GATEWAY PARK III FILING NO. 4 BUILDING EIGHT SITE PLAN WITH WAIVER REQUEST SHEET 1 OF 2

BUILDING EIGHT
32nd Ave. and Lewiston St.
Aurora, Colorado

Gateway Park III Filing No. 4 Bldg 8 97-6007-1

GATEWAY PARK ROAD EXTENSION
SCHEMATIC GRADING PLAN

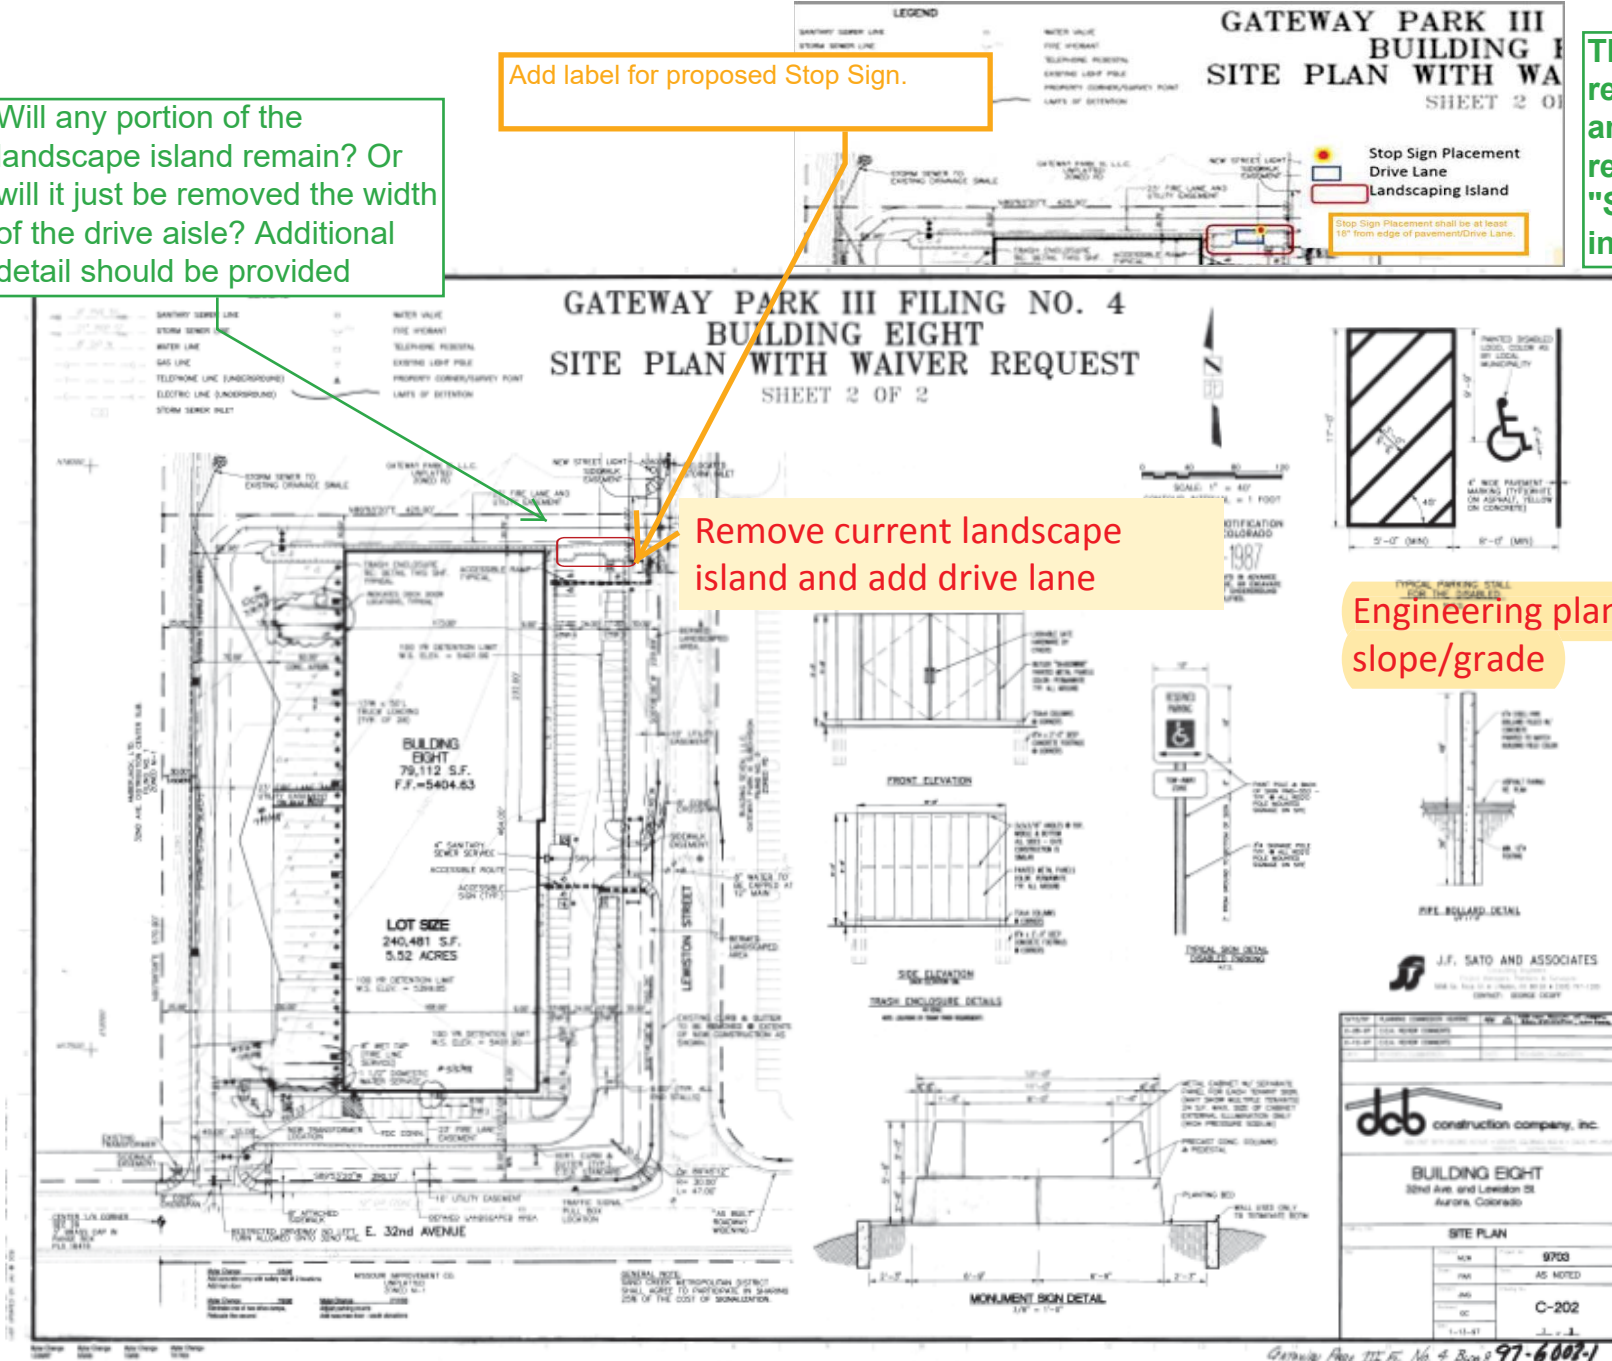
Will any portion of the landscape island remain? Or will it just be removed the width of the drive aisle? Additional detail should be provided

Add label for proposed Stop Sign.

The site photo seemed to show significant grade difference. Please provide a grading plan.

Remove current landscape island and add drive lane

Engineering plans submitted for slope/grade

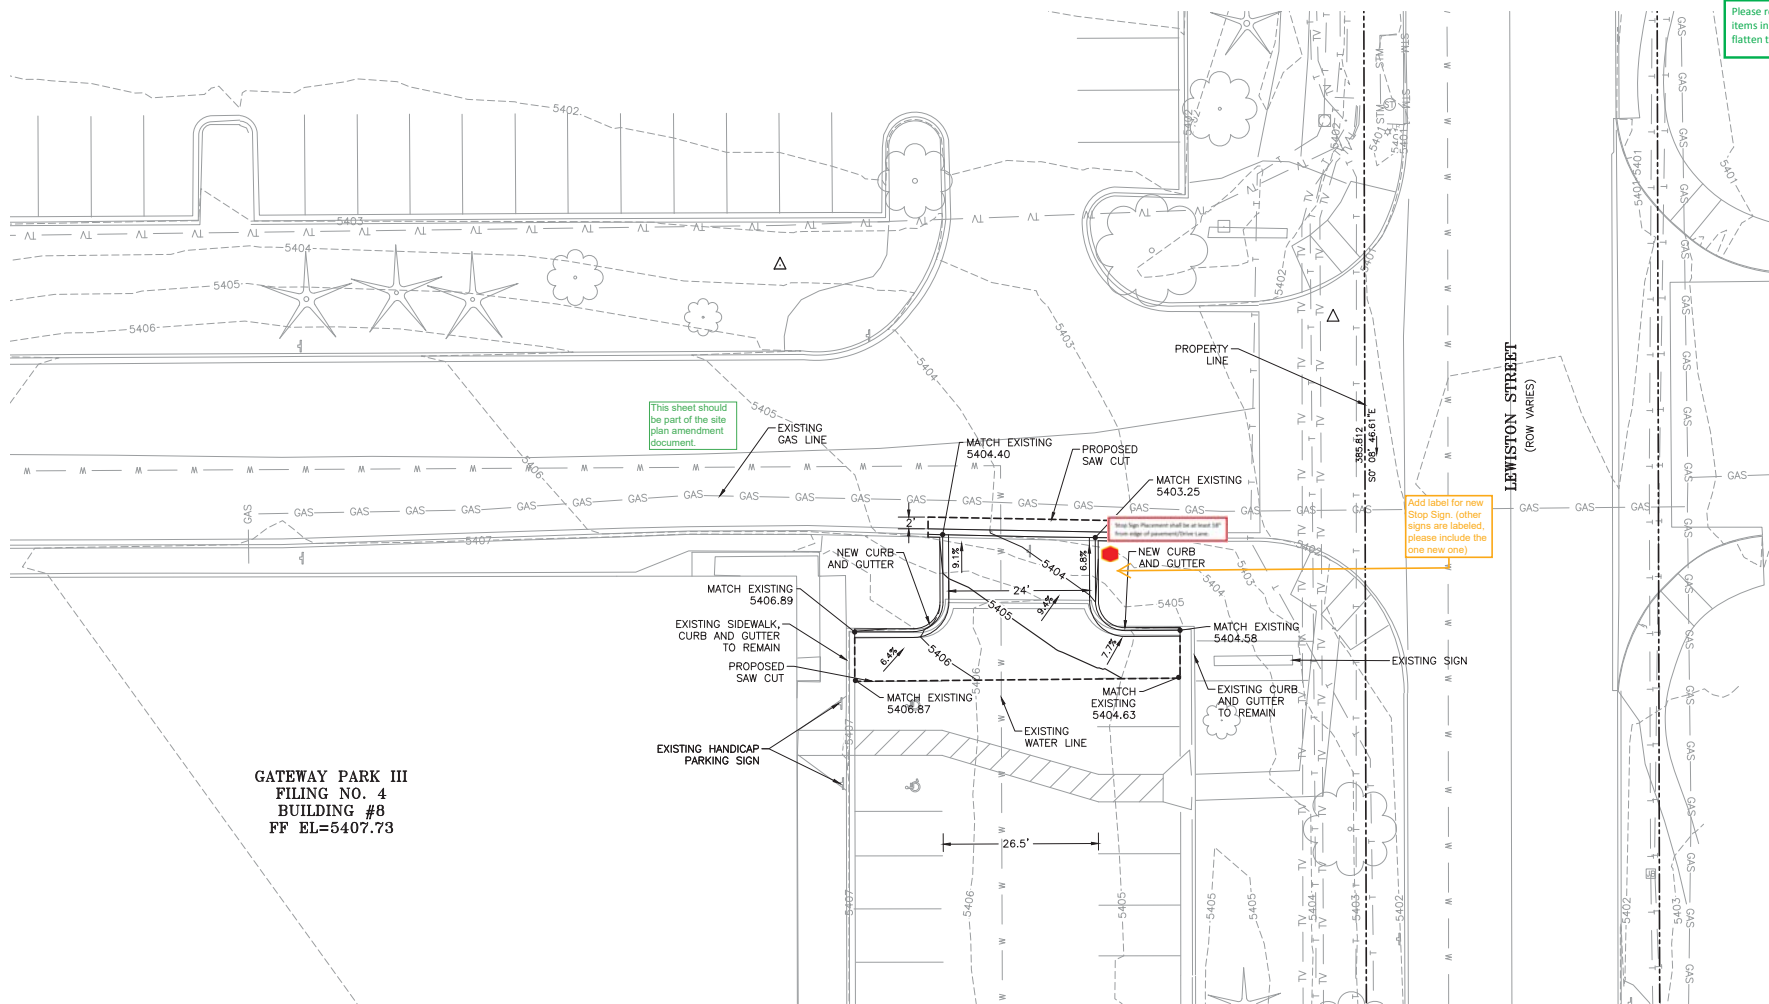
Please remove AutoCad SHX text items in the comment section. Please flatten to reduce select-ability of the items.
